Mynydd Llanhilleth Wind Farm

Environmental Statement

Appendix 14C JRC Assessment

WF Coordination - Further Analysis Engineering Notes

The Signal Paths and Cross-Section diagrams for Turbine 3 and link in the nominal positions are shown:

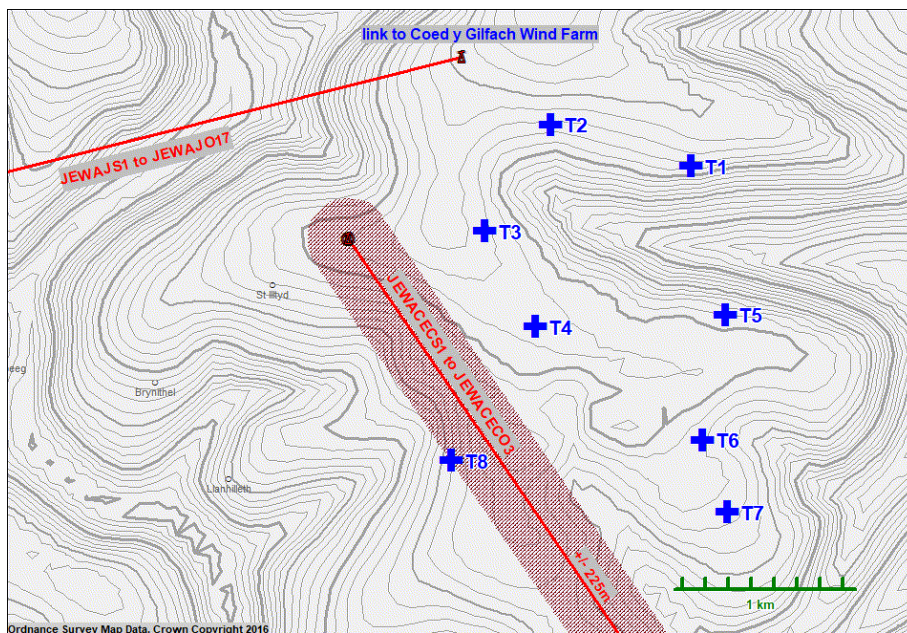
The signal path diagram shows the signal reflection criteria, where unacceptable interference could occur when the signal from the secondary path via the Wind Turbine is large compared with the direct signal path.

In this instance, when taking into account terrain and clutter, the direct signal path is not significantly more obstructed than the signal path via Turbine 8, and despite the proximity of the turbine to the link, the ratio of wanted to potentially reflected signal is just acceptable.

Given that turbine T8 only just passes the reflection criteria, an exclusion region of +/- 225m has been defined around link JEWACECO3. The link path to the Coed y Gilfach Wind Farm is unaffected but shown for reference.

It is considered that, subject to turbines not entering the exclusion zone, the proposal could be accepted. The final decision on acceptance, would be with the link operators, National Grid Telecoms.
